**WATER RESOURCE
DEVELOPMENT PROJECT**
CHANNEL REHABILITATION PROJECT
LOCAL PROTECTION

DESIGN MEMORANDUM NO. 1

DAEN-CWE-BB (NEDED-E, 9 Dec 77) 1st Ind
SUBJECT: Channel Rehabilitation Project, Local Protection, North
Nashua River Basin, Fitchburg, Massachusetts; Combined
General Memorandum No. 1, Phase I - Plan Formulation and
Phase II - General Design

1. The subject design memorandum is approved, subject to the comments in the following paragraphs.
2. The local cooperation requirements on page 6 should quote verbatim the requirements as stated in the Senate Document 113, 89th Congress, 2nd Session, North Nashua River and tributaries, Merrimack River Basin, Massachusetts, 6 October 1966 (see ER 1110-2-1150, Appendix A, paragraph 2a). The local cooperation requirements on page 63 should be modified by ~~the~~ adding to the hold and save clause (paragraph b) "except damages due to the fault or negligence of the United States or its contractors," as required by Public Law 93-251. The formal local cooperation agreement wording of the local cooperation requirements must be in strict conformance with the project document wording as modified by Public Law 93-251.

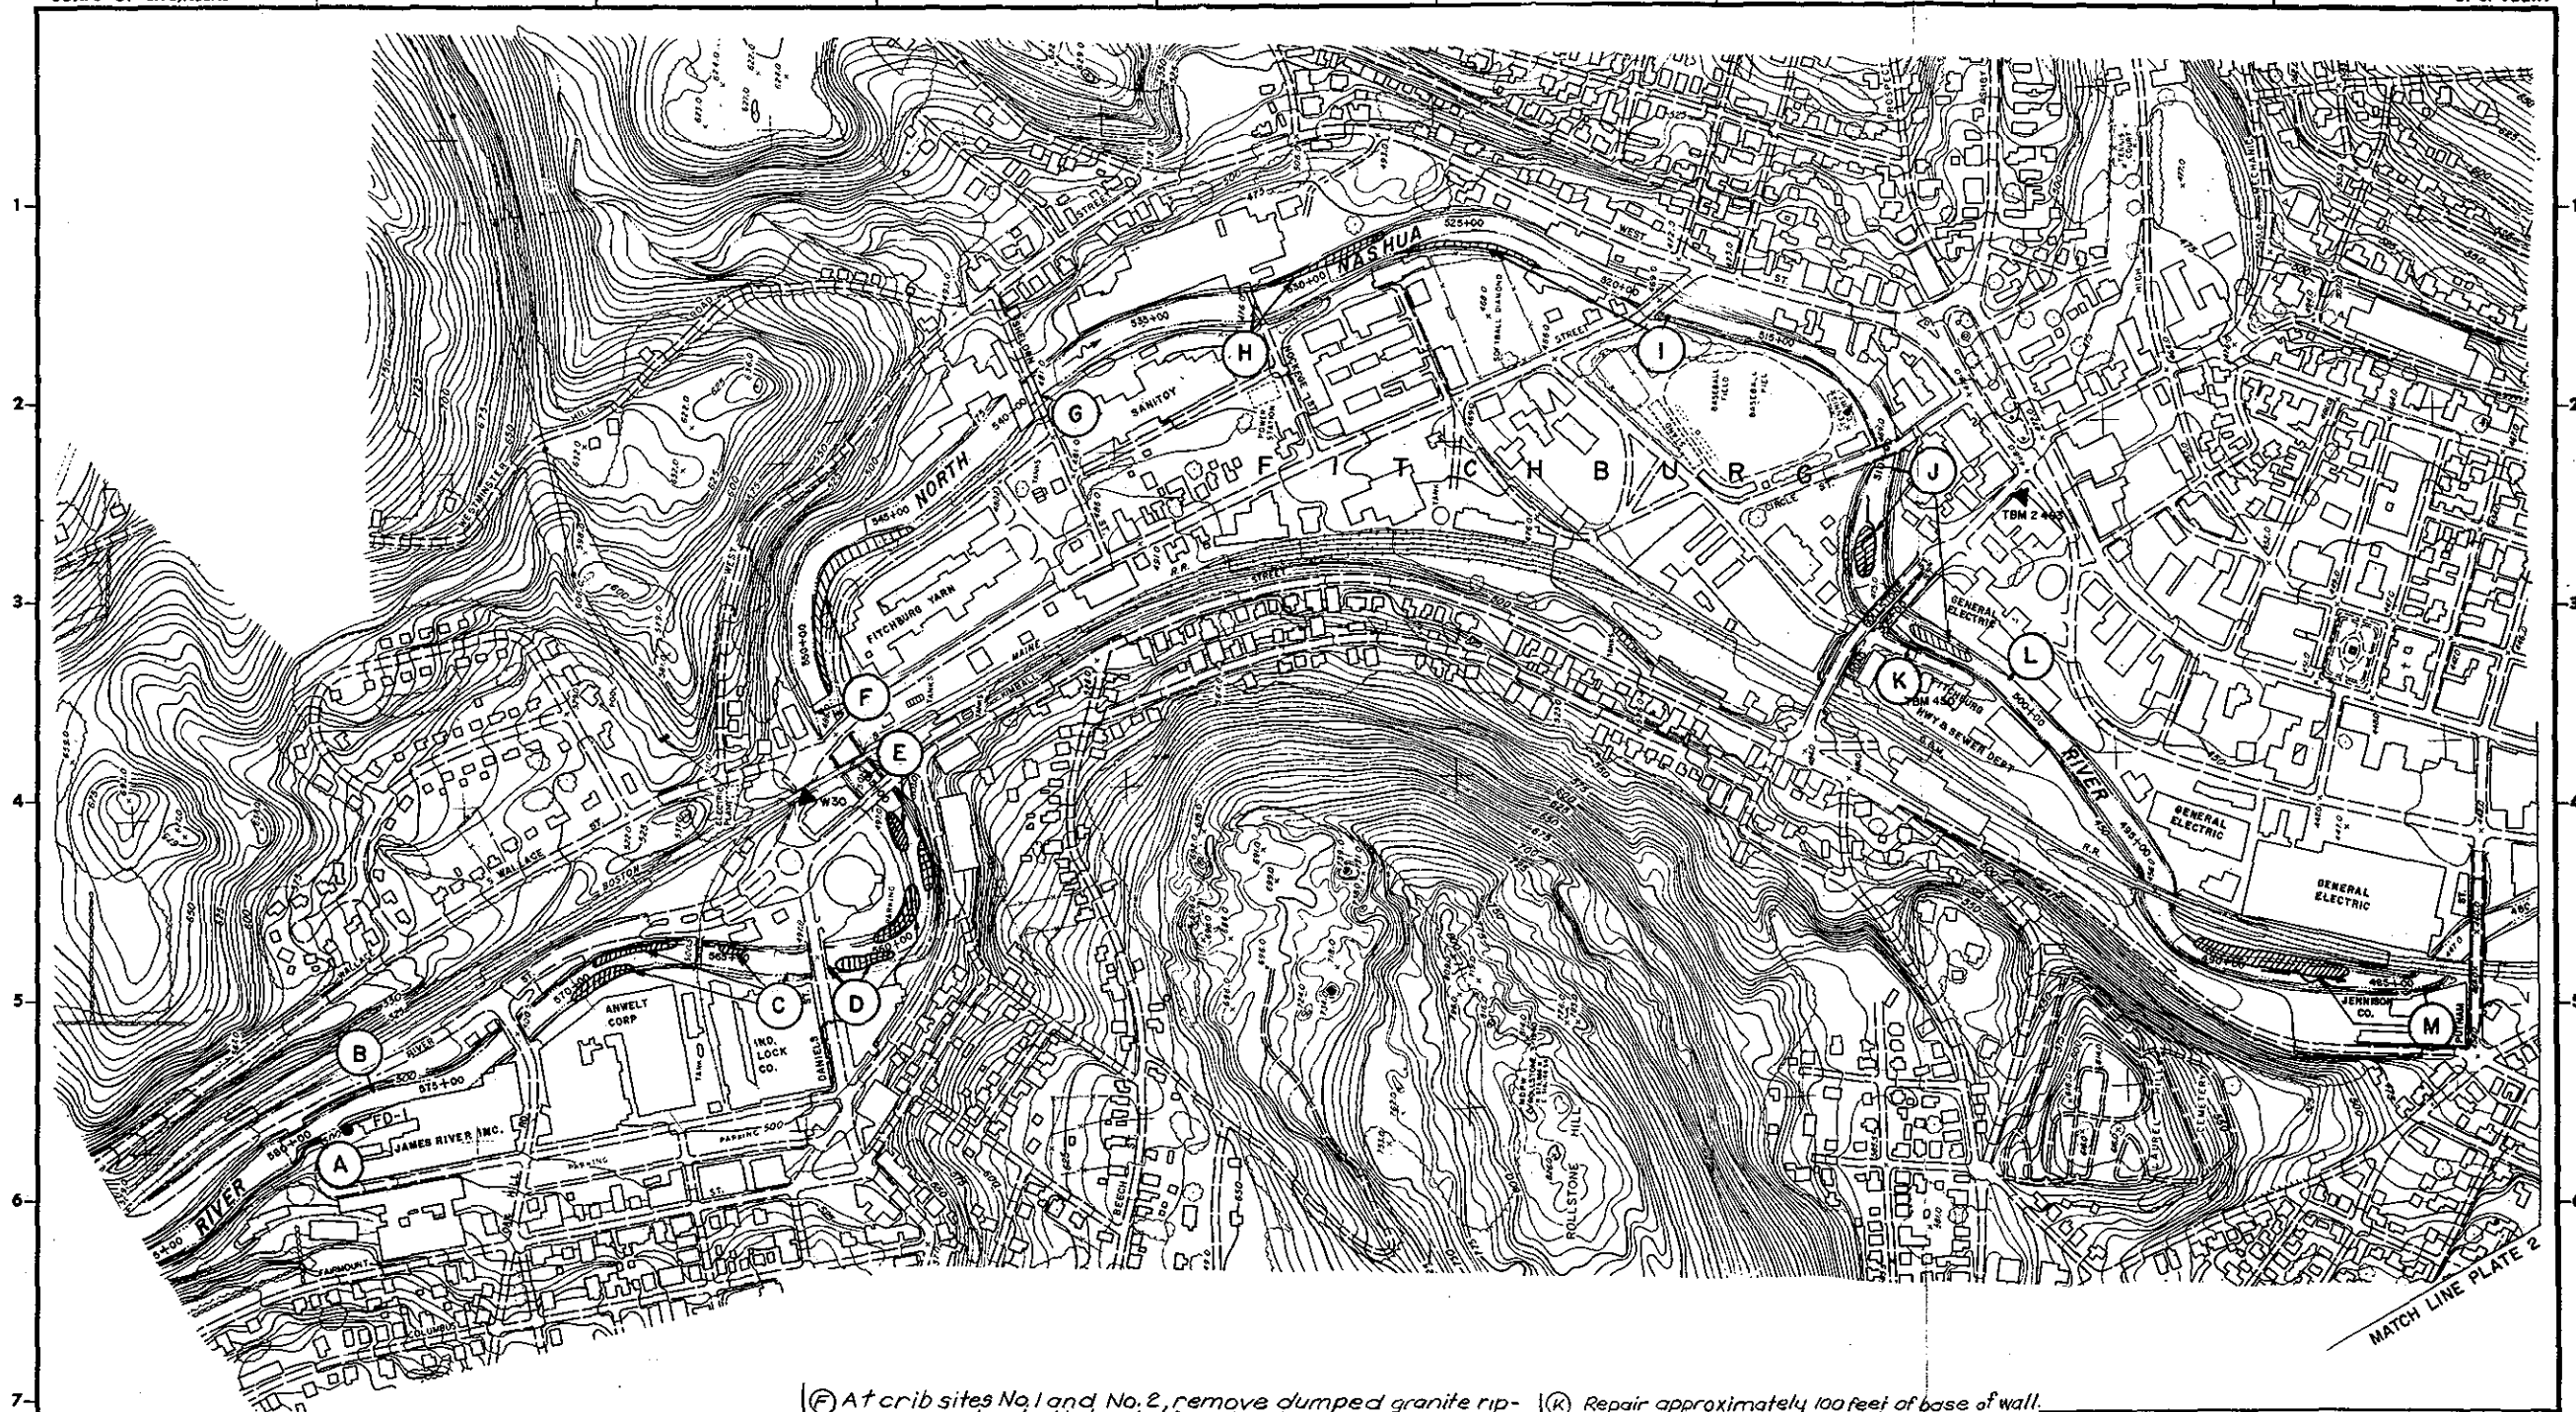
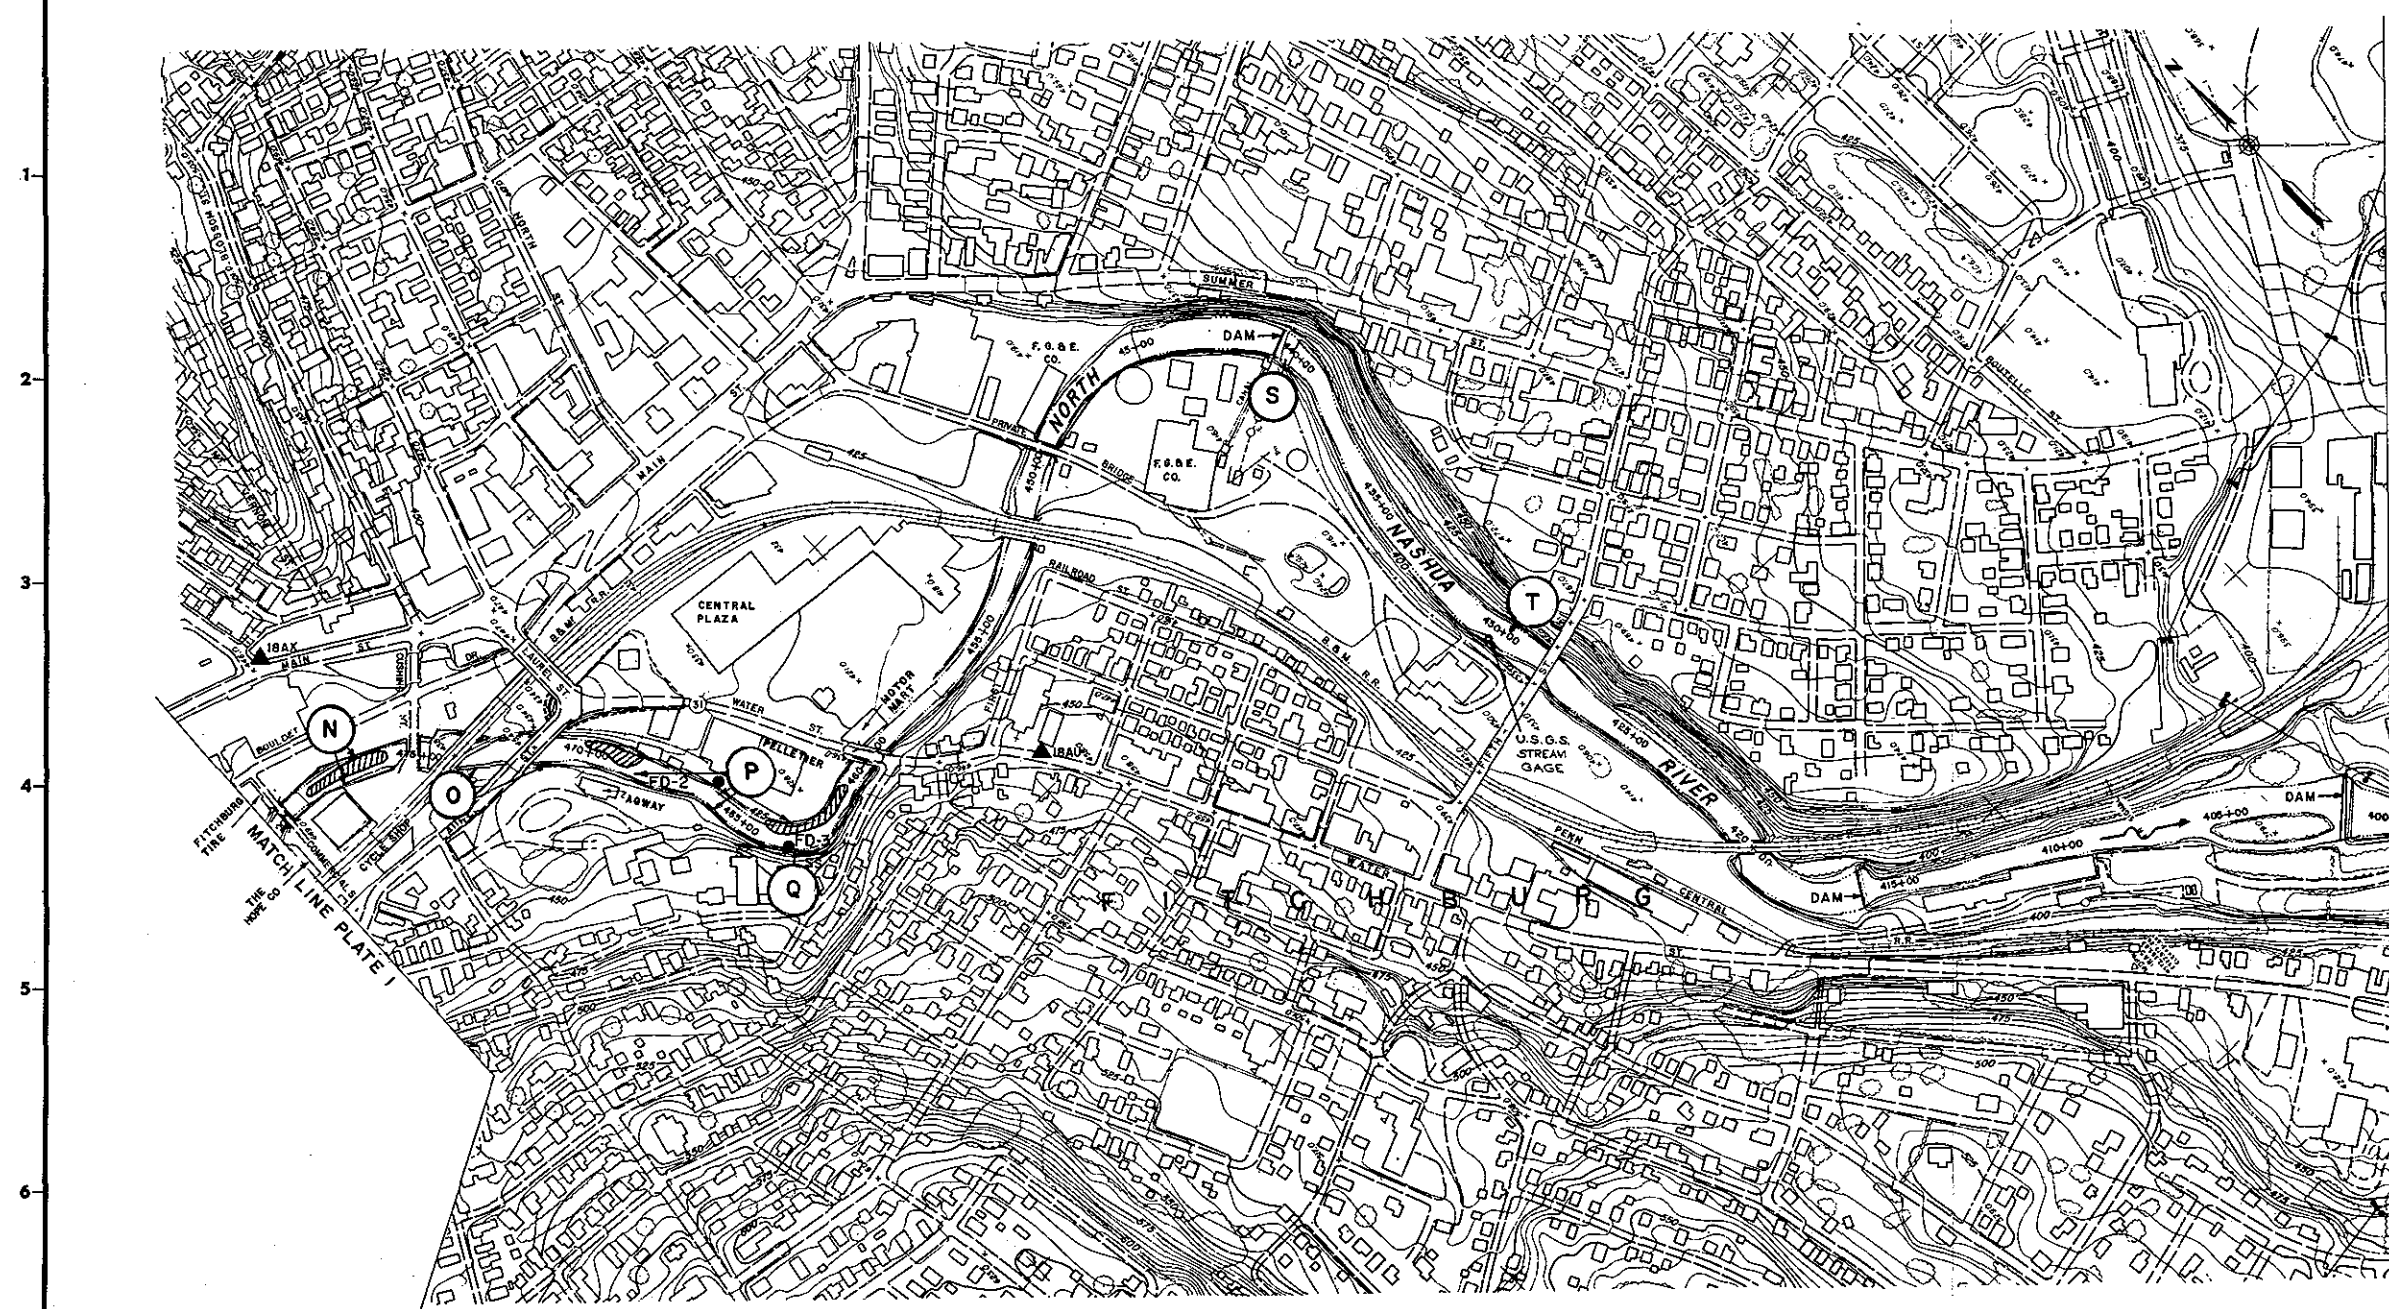
3. Plates 1, 2, and 4. Plans and specifications should provide for positive drain measures where cut stone or riprap is to be grouted.
